RENESAS TECHNICAL UPDATE

Classification of Production	MPU&MCU		No	TN-SH7-492A/E	Rev	1
THEME	Notice about The MMCIF transfer data block size in multiblock read command.		Classification of Information	1. Spec change 2. Supplement of Documents ③. Limitation of Use 4. Change of Mask 5. Change of Production Line		
PRODUCT NAME	SH7760	Lot No.	Reference Documents	SH7760 hardware manual (ADE-602-291)	Effective Date	
		All			Eternity

figure.1 Timing of receiving the command response and data

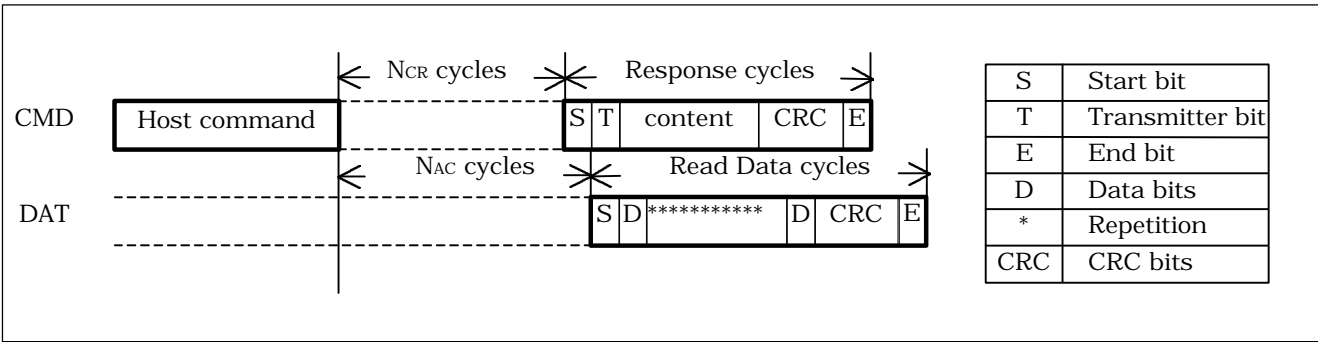
The MMCIF may not receive the command response correctly, when it finishes receiving the end bit of the first data block before receiving the end bit of the command response. It may occur after MMCIF sends CMD18 to the receive device.

- (1) The multiblock read command (CMD18) is sent.
- (2) The transfer data block size is setting to 1,2,4 or 8 byte(s).
- (3) The end bit of the command response is received after the end bit of the first data block is received.

- (2) Confirm that the end bit of the command response is received before the end bit of the first data block is received, if the transfer data block size is 1,2,4 or 8 bytes when CMD18 is transmitted.

Keep the below formula in order to confirm that the end bit of the command response is received before the end bit of the first data block is received.

$$\text{NAC cycles} + \text{Read Data cycles} > (\text{NCR Cycles} + \text{Response cycles})$$

Please confirm the NAC and NCR in the spec of target devices to communicate.
